Proposed Anaerobic Digestion Facility
Spring Grove, Horseheath

Transport Addendum

Acorn Bioenergy Limited

- 1.1 This addendum transport report ('Report') is prepared in relation to planning application SCC/0045/23SE (the 'Planning Application'), which seeks permission for the "*construction and operation of an anaerobic digestion facility, associated infrastructure and new access road, connecting pipeline and covered digestate lagoons*" (the 'Proposed Development') on land north of Spring Grove Farm, Cambridge Road, Withersfield, Suffolk (the 'Application Site'). The new anaerobic digester (AD) would be fuelled by a combination of animal and agricultural waste to deliver "green gas" to the gas network.

Figure 4.1 – 2022 Base + Development AM & PM Peaks

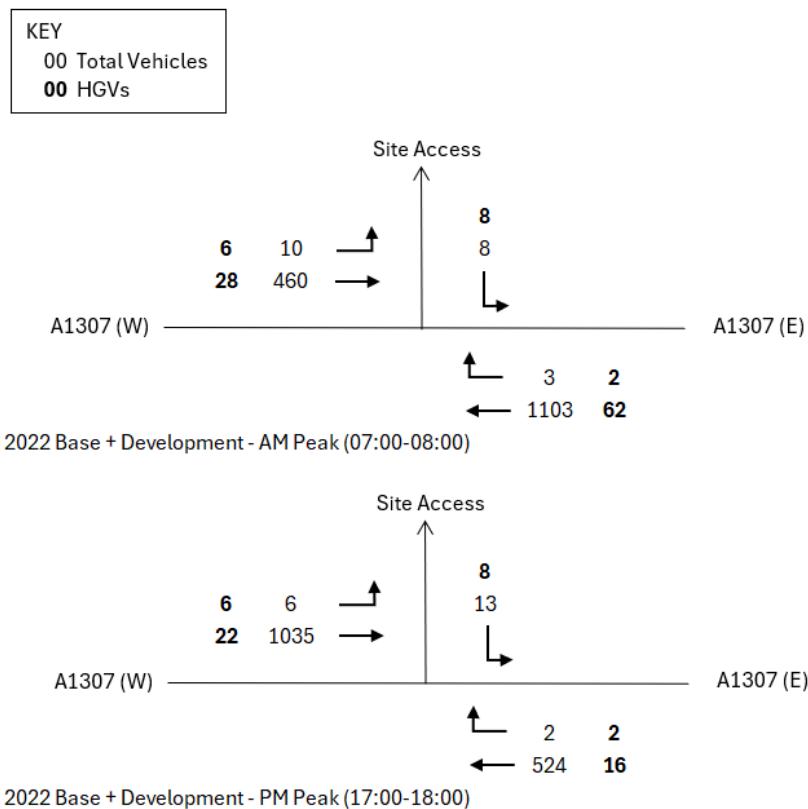
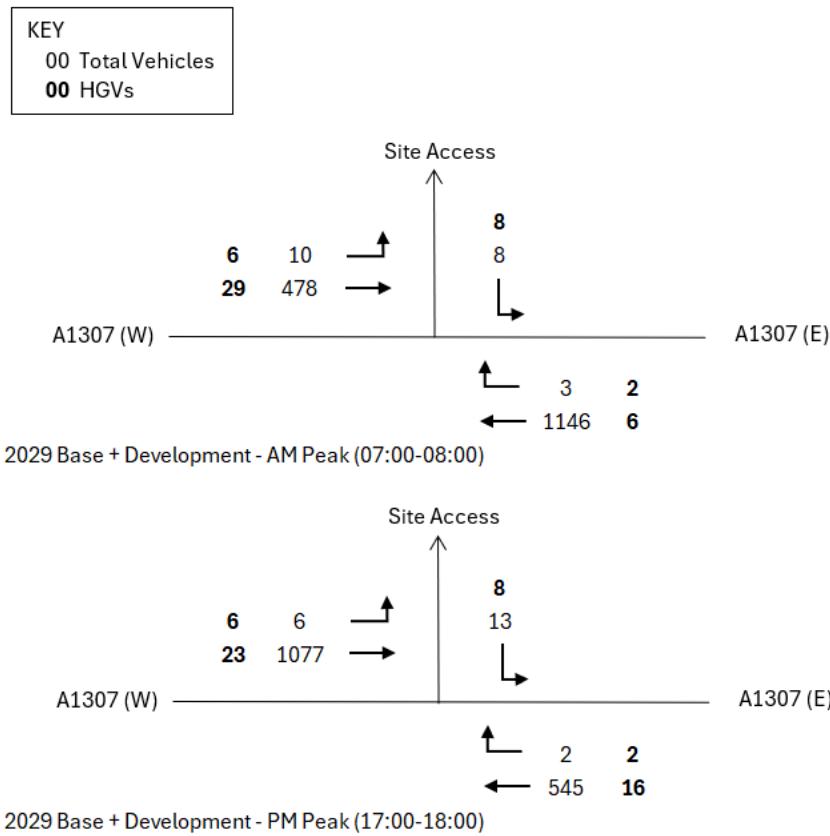
"4d: Further information to evidence that the proposed number of operational trips will not detrimentally affect the highway is required."

4.2 Junction capacity modelling has been undertaken for the site access. This is based on the peak trip generation presented in the TAR and the ATC data.

4.3 The distribution of development trips has been based on the information presented in the TAR (Table 6-2) whereby 75% of trips have been assigned to the west and 25% of trips have been assigned to the east.

4.4 Figure 4.1 and 4.2 shows the junction diagrams for the '2022 Base + Development' and the '2029 Base + Development' for the AM (07:00-08:00) and PM (17:00-18:00) peaks. The future year 2029 has been selected to reflect 5-years post the preparation of this report and the 2022 ATC data has been growthed using TEMPro (v.8).

4.5 The operation of the site access has been modelled using PICADY based on the weekday AM peak (07:00-08:00) and PM peak (17:00-18:00) hourly periods for the years 2022 and 2029. The results are summarised in Table 4.1 and 4.2. The full output is included as [Appendix B](#).

Figure 7.1 – PIC Locations

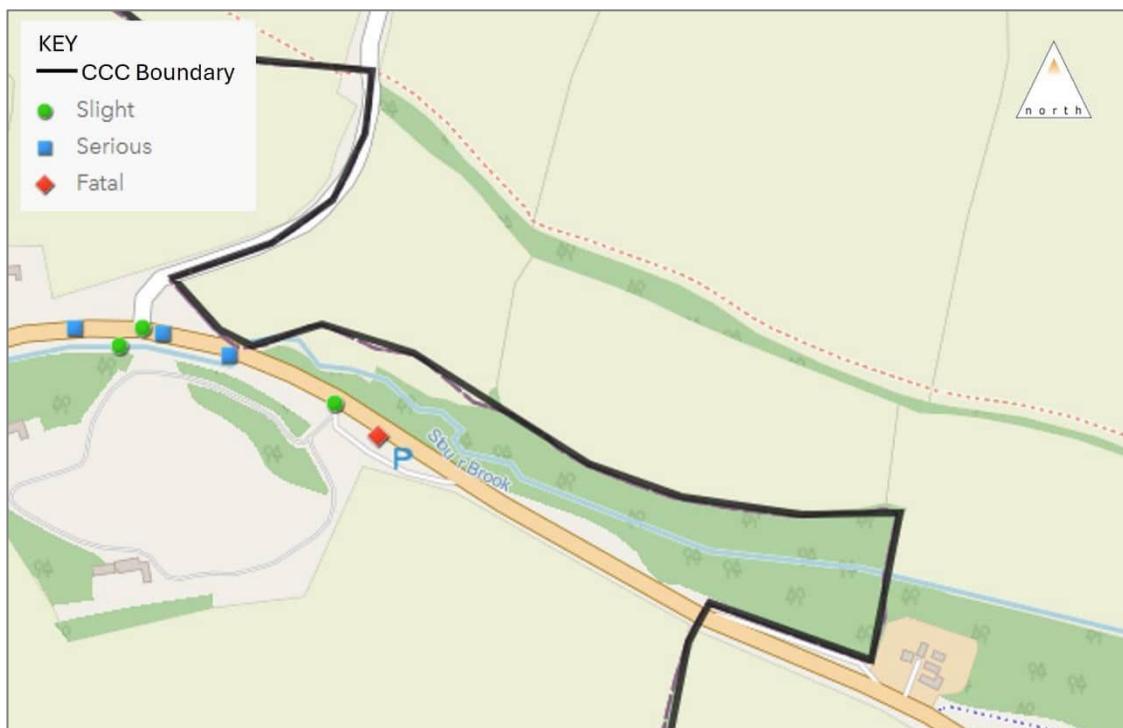
"3a: Data from Cambridgeshire County Council's accident data portal needs to be included within the transport assessment."

7.2 CCC have requested that data from their accident portal is reviewed. The locations of Personal Injury Collisions (PICs) are shown in Figure 7.1 reflecting the study area assessed in the TAR within the CCC boundary.

7.3 One fatal PIC was recorded on the A1307 in the vicinity of the parking layby, approximately 500m west of the site access which involved two vehicles in dark conditions.

7.4 Three serious incidents were recorded in the vicinity of the Silver Street / A1307 priority T junction:

1. Circa. 80m east of the T junction the PIC involved two vehicles in dark conditions.
2. At the junction there was a four-vehicle collision in wet / damp conditions as a vehicle was waiting to turn right.

- 3. Circa. 70m to the west of the T junction the PIC involved only one vehicle.
- 7.5 Two slight incidents were recorded at the Silver Street / A1307 priority T junction of which one PIC involved two vehicles as a vehicle was waiting to turn right and the second PIC took place in dark and wet / damp conditions with two vehicles.
- 7.6 A further slight PIC was recorded circa. 170m to the east of the T junction in the vicinity of the parking layby which involved two vehicles as a vehicle was waiting to turn right.
- 7.7 From this review no significant patterns or trends have been observed that would be exacerbated by the Proposed Development, in particular as the Proposed Development would change the volume of traffic by less than 1%. It is therefore concluded that the proposed development would not have an adverse impact on highway safety.
